VOLUME II
APPENDIX C
COMMENTS OF
THE S. W. SHATTUCK CHEMICAL COMPANY, INC.
ON THE
DENVER RADIUM SITE OPERABLE UNIT VIII

**Preliminary
Environmental Audit**

Envirocare of Utah, Inc.
Tooele County, Utah

Project No. D0297
May 1991

CONTOUR MAP ON TOP OF LOWER
SILTY CLAY UNIT

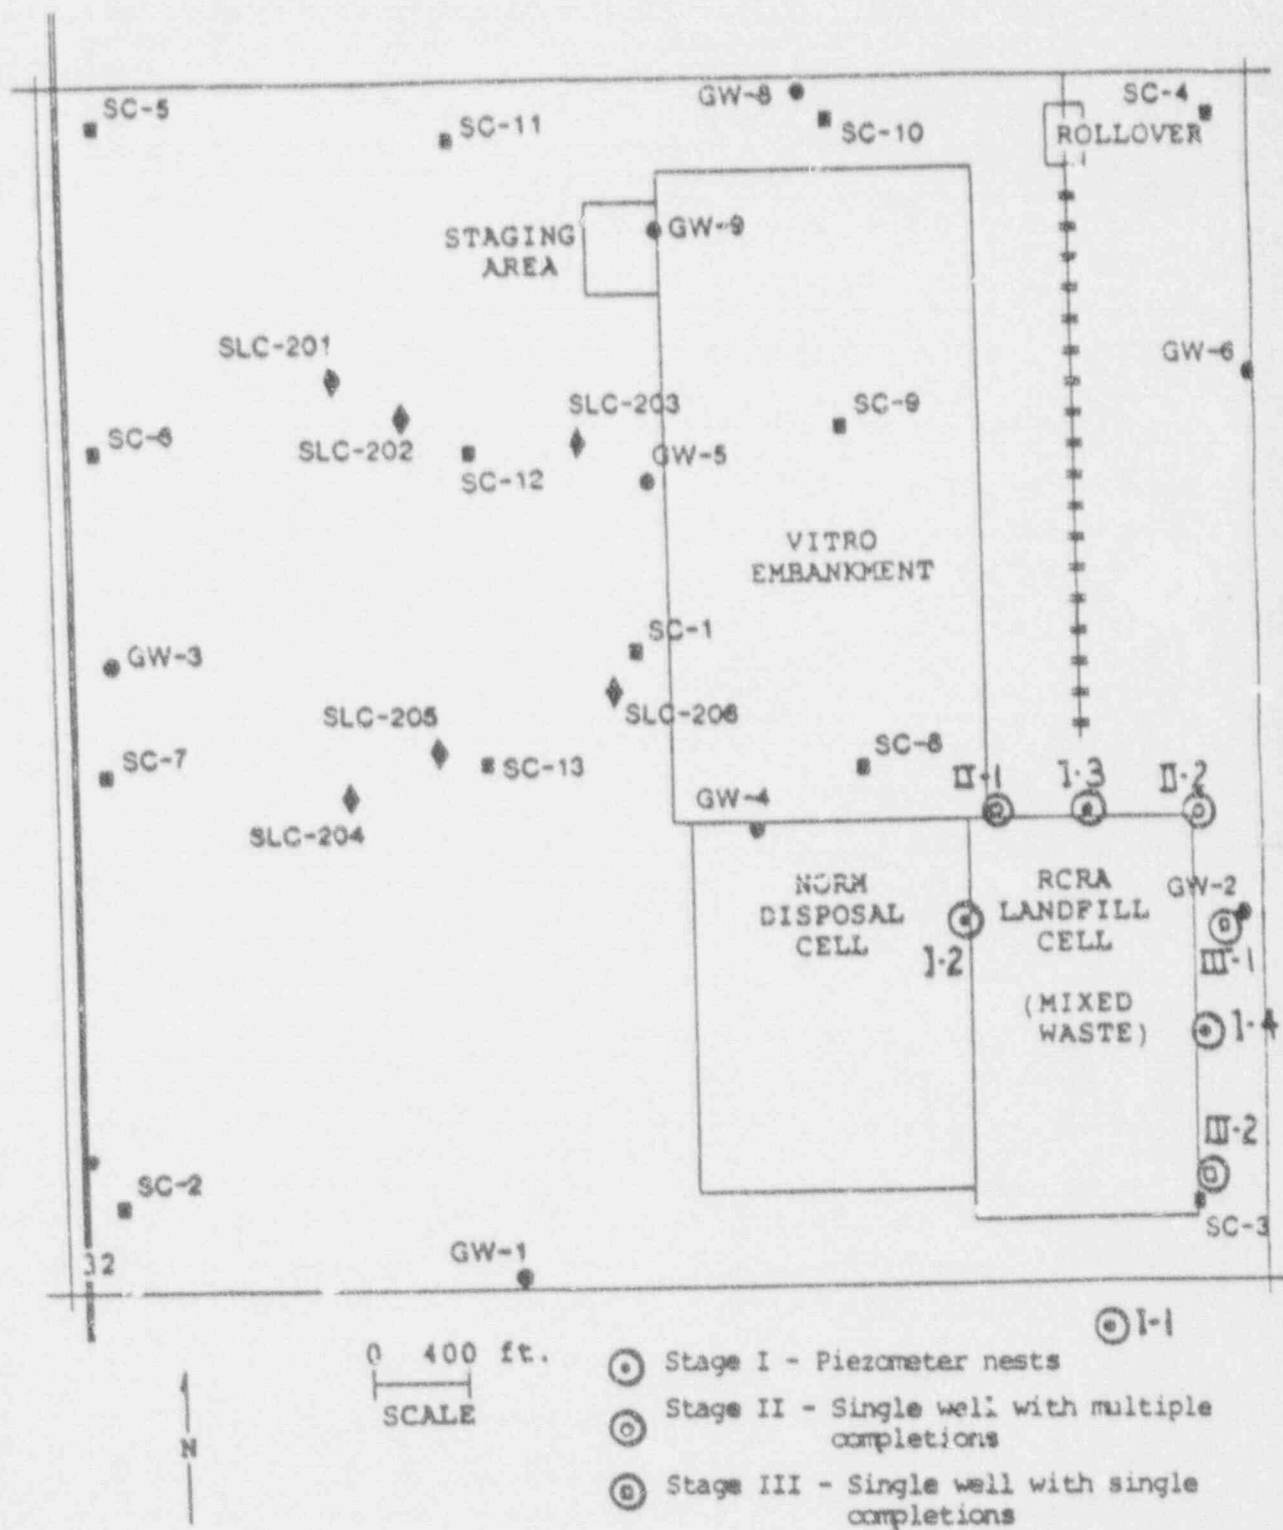
The letter transmitting Delta's report depicts the hydrogeologic conditions as well characterized by data obtained from existing reports and ongoing measurements of depth to water. Figure 1 (Figure 5 from the Delta report) shows the monitoring well locations and designations at the time of the report. In their transmittal letter, Delta cites that a "general northerly trend in flow direction is evident." This flow direction is portrayed in Figure 2 (Figure 7 from the Delta report). Our review of the information presented in Delta's report and other available references on the area (1) could not reach a similar conclusion regarding groundwater flow direction, and (2) suggests that hydrogeologic conditions are not well characterized by existing information.

The water elevation in all accessible monitoring wells was surveyed as part of Delta's investigation. These water level measurements are presented in Figure 3 (Figure 6 from the Delta report). Our review of Figure 3 suggests that no flow direction trend is apparent from these data, a conclusion shared by Delta's investigators. The groundwater flow direction is controlled by the hydraulic gradient (the slope of the water table surface). To determine the hydraulic gradient in a particular hydrostratigraphic unit, monitoring wells should be completed only in that unit. Since many of Envirocare's monitoring wells are screened in more than one hydrostratigraphic unit, the resulting water level

Based on our understanding of the disposal operation and local hydrostratigraphic conditions, seepage from the NORM-waste disposal embankment would enter the sand unit, migrate downward until it met a less permeable layer, and then flow laterally along that layer. The sand unit is underlain by a silty clay unit that is several orders of magnitude less permeable. Using boring logs and well completion records for the existing monitoring wells, we contoured the elevations of the base of the sand unit (Figure 4). The surface of the silty clay unit slopes in a west-southwestern direction. Since the sand unit is locally above the water table, seepage infiltrating from the embankment would be controlled to some extent by the top of the less permeable silty clay surface beneath the sand unit. Flow along this surface would be in a west-southwestern direction. Again, neither Envirocare nor Delta address this flow direction.

A review of Figure 5 (Figure 8 from the Delta report) shows the placement of existing monitoring wells plus the new wells proposed by Delta to monitor the mixed waste embankment. Few monitoring wells exist west or southwest of either the NORM- or mixed-waste disposal embankments. Considering that the groundwater flow direction is not well established, we believe the existing and proposed networks are deficient. Monitoring wells are required adjacent to the facilities on the west, southwest, and south to define the actual hydraulic gradient. Additionally, monitoring wells should be constructed in each hydrostratigraphic unit. Instead, more than one hydrostratigraphic unit is monitored by many existing wells and the existing and proposed monitoring wells are concentrated to the north, northeast, and northwest of the active NORM disposal operations.
